Bowness Resident Request on Bowness Barrier – Lack of Consultation

Presented by: David Chalack resident and owner 7020 Bow Cres NW

Presented by Dr. Tadeusz Dabrowski P.Eng.

May 15, 2019

City of Calgary Groundwater 101 Video

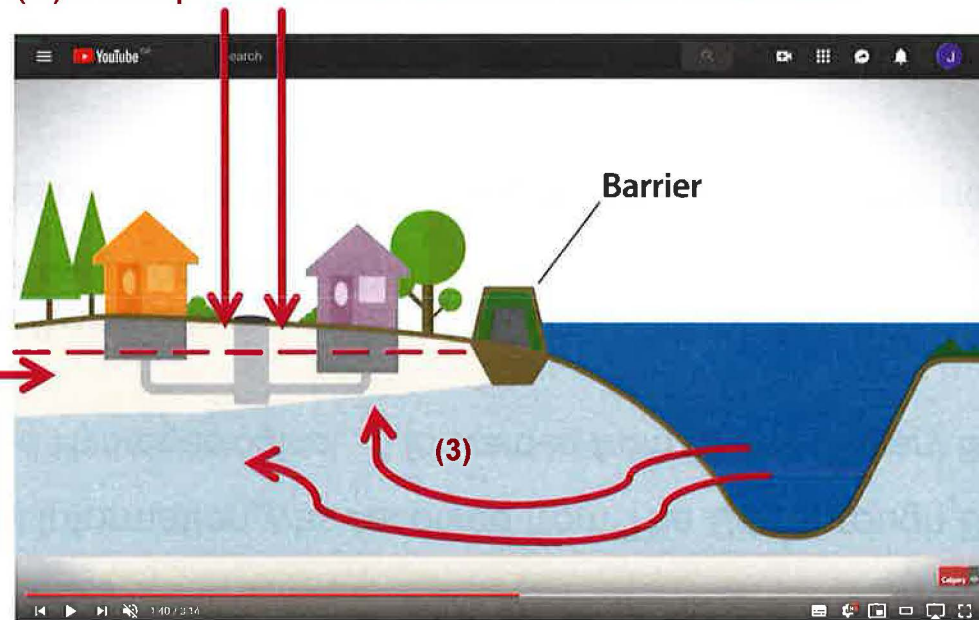
The video available on project website that is used to educate the public is missing 3 key components

Video shows that barriers lower groundwater surface BUT THEY DO NOT DO NOT

Drains DO lower groundwater surface

(2) Precipitation and runoff from the Paskapoo slopes in the south raises the level of the groundwater surface

(1) Precipitation and surface runoff infiltration

(3) River infiltration

AE Report

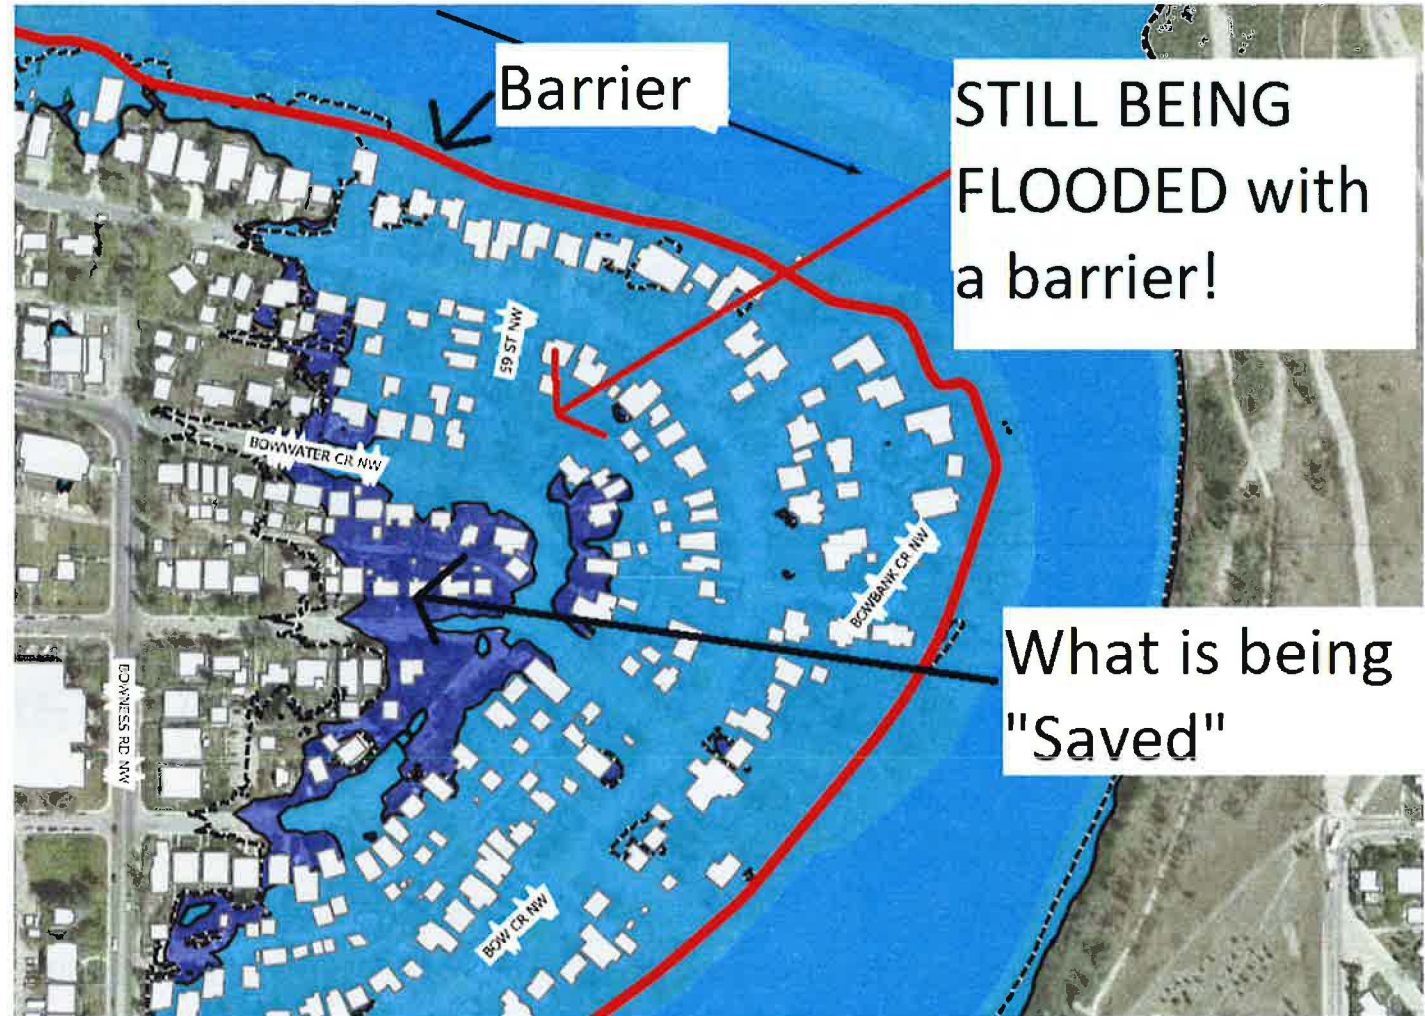
- Blue area is where Groundwater is within 1.4 meters of surface
- Condition evaluated includes barrier and river level at 1230 m³/sec flow rate.
- Evaluation based on average or expected permeability. Actual permeability from Groundwater Study could be higher

Bowness Berm Cross Section

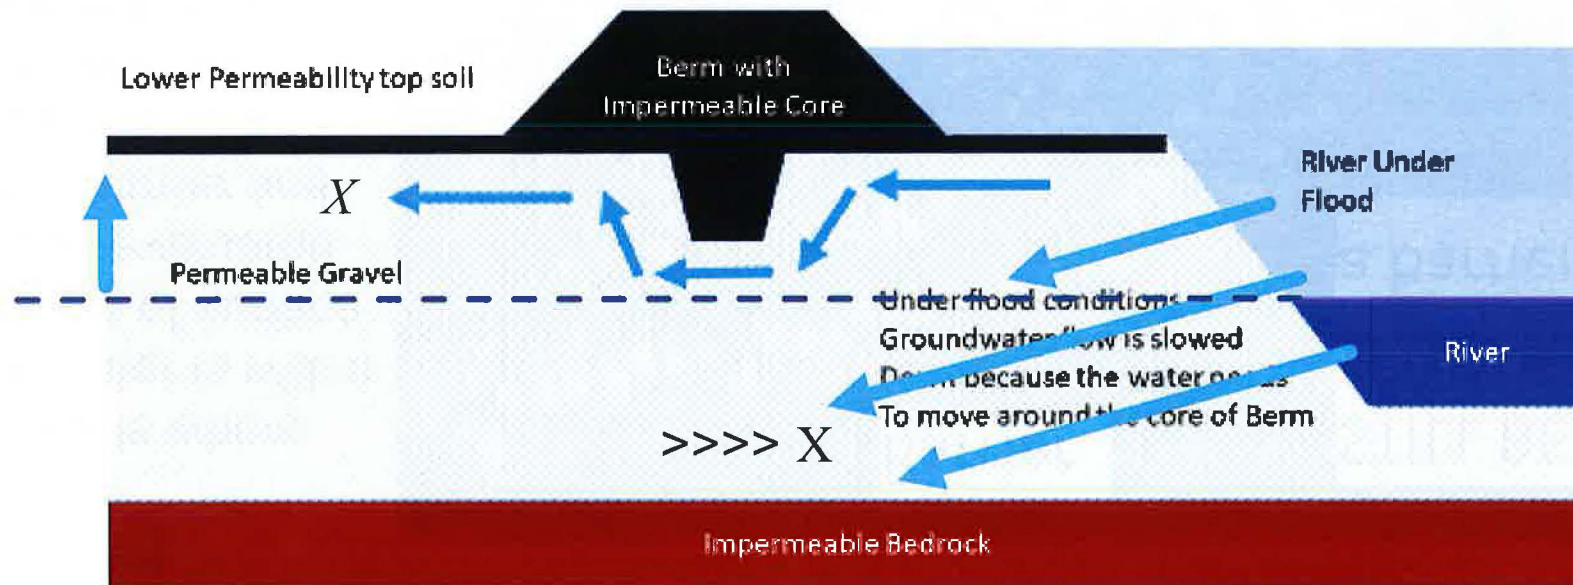
During a flood, the aquifer will fill both laterally and from the bottom up. As the berm core is 2m thick and the underlying permeable deposits in Bowness many metres thicker, the effect of the berm on groundwater migration timing will be negligible!

FMMA solution involves increasing trigger flow rate for storage to 1230 m³/sec

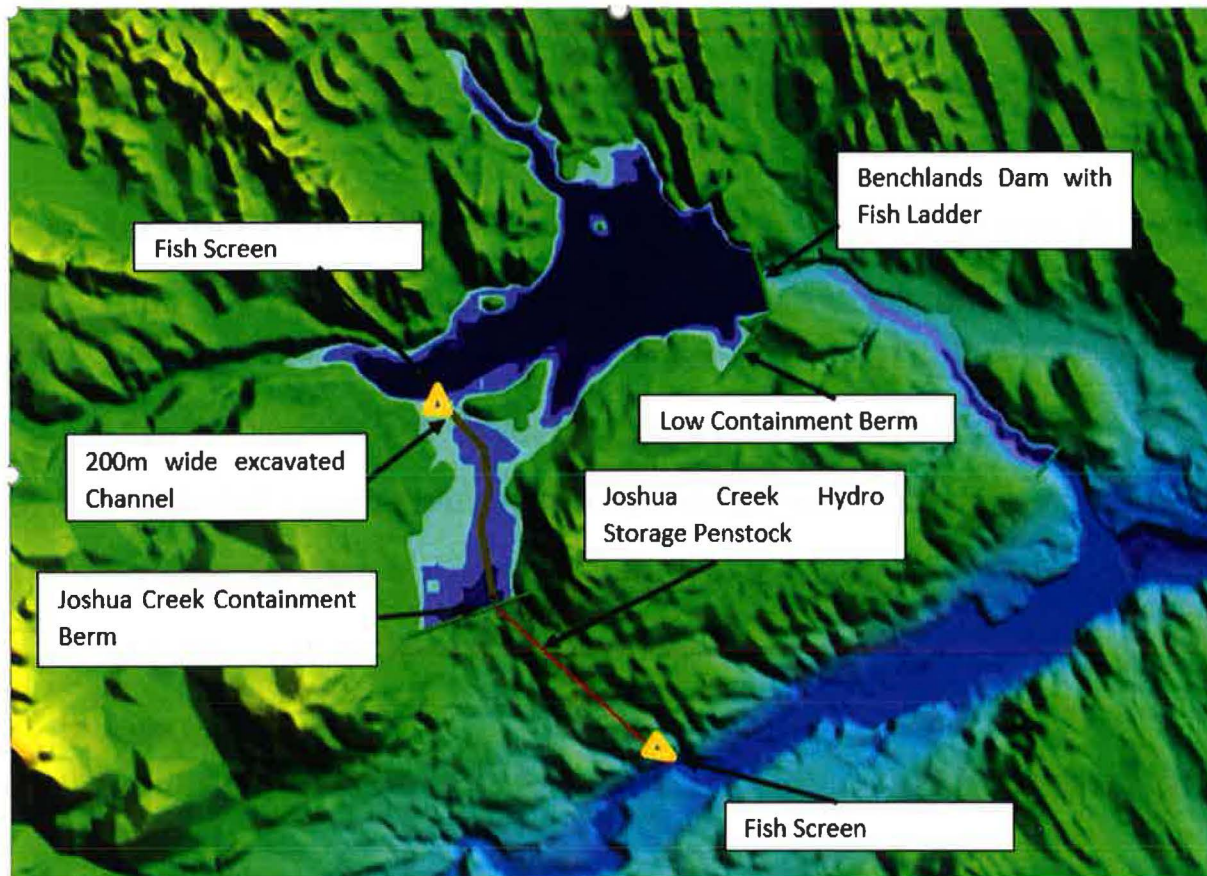
- BRFM Does not accept this option We have not been consulted on this
- There is no evidence provided that Bowness Barrier will facilitate flow of 1230 m³/sec without significant increased Groundwater flood damage
